Conners, inc. 84 cutler st. #3 | warren, ri 02885 401-289-2942

Revolver
Revolver Overview
Scale: as noted
Drawn on: 11/7/2014
Revised on:

1 Revolver R1 scale = 1:12

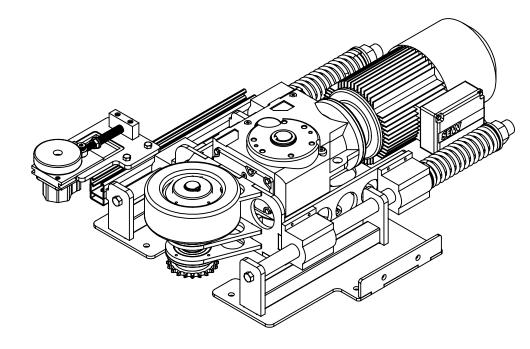
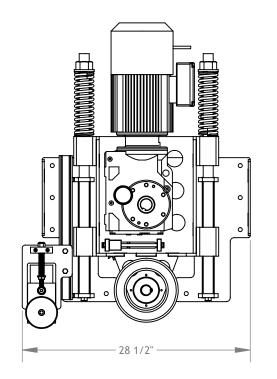
REVISIONS		
ĺ	Rev.	Drawn	Date	Revisions
	Α	RLM	11/7/2014	Moved top bearing plate down to allow for wheel to travel higher
